Wizards Workshop

September 19, 1980
Issue 10-19

DIAGRAM 'C'

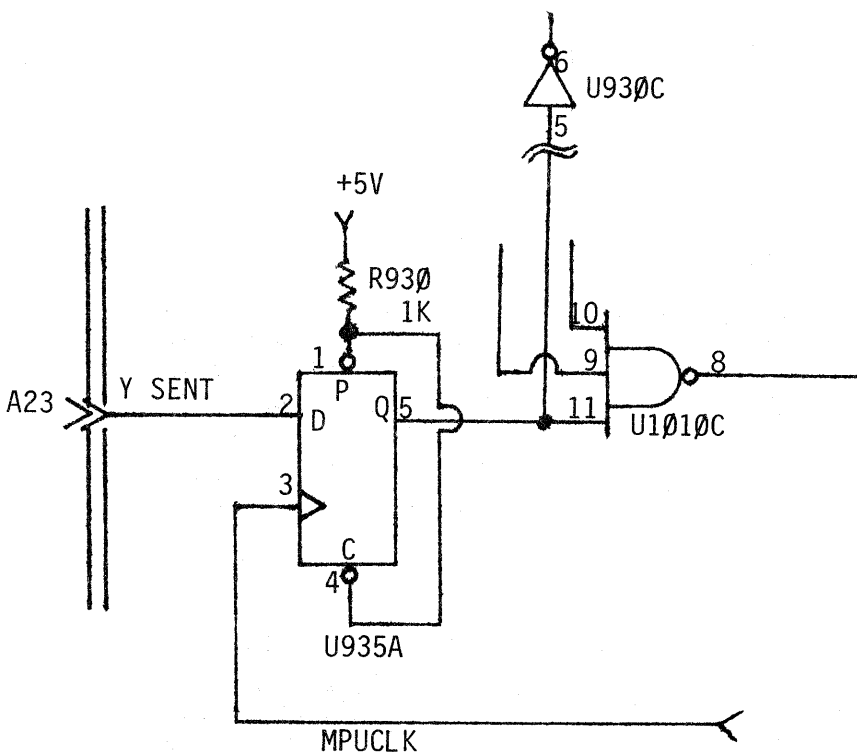
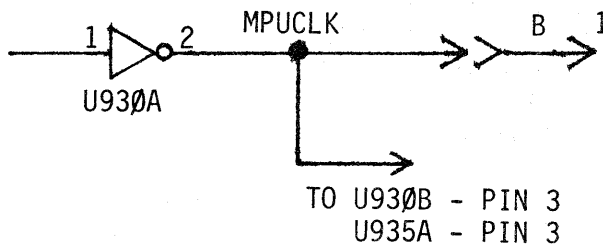
The schematic representation is shown in diagram 'C'.

DIAGRAM 'A'

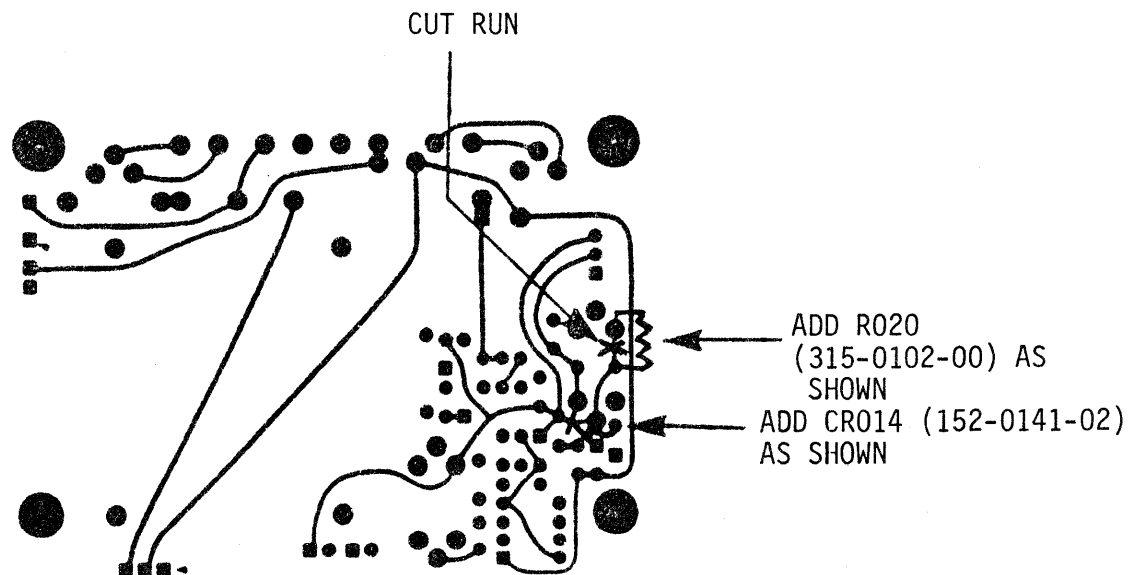
Solution: On the front side of the Hi Voltage Oscillator Circuit Board 670-5155-01, add two heat sinks (214-0269-00), one to Q016 and one to Q018. Remove VR016 and replace with Part Number 152-0304-00.

As shown in diagram 'A' cut a run, add R020 (315-0102-00) between collector of Q012 and the base of Q014 and add CR014 (152-0141-02) between the emitters of Q014 and Q002.

DIAGRAM 'B'

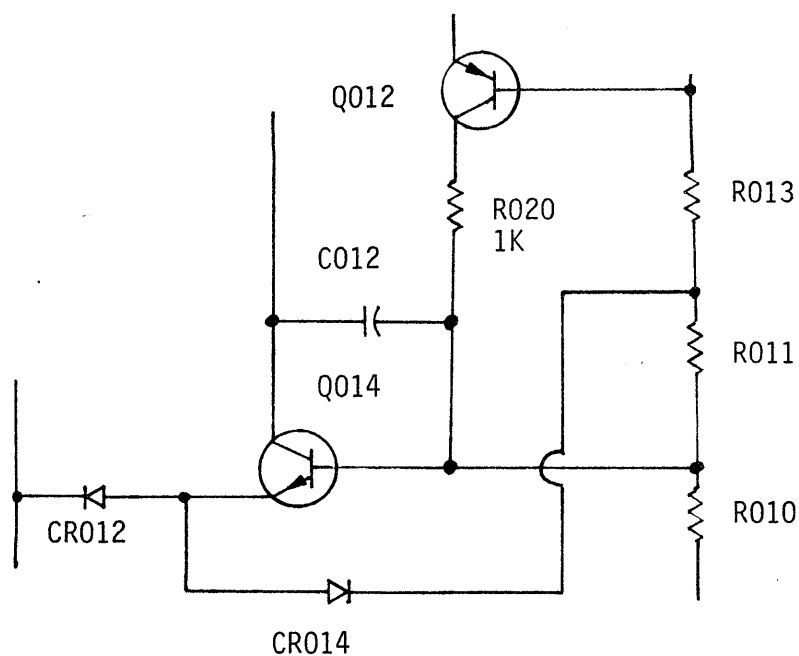
Diagram 'B' is the schematic equivalent of this modification.

This modification changes the Hi Voltage Oscillator Board from a 670-5155-01 to a 670-5155-02.
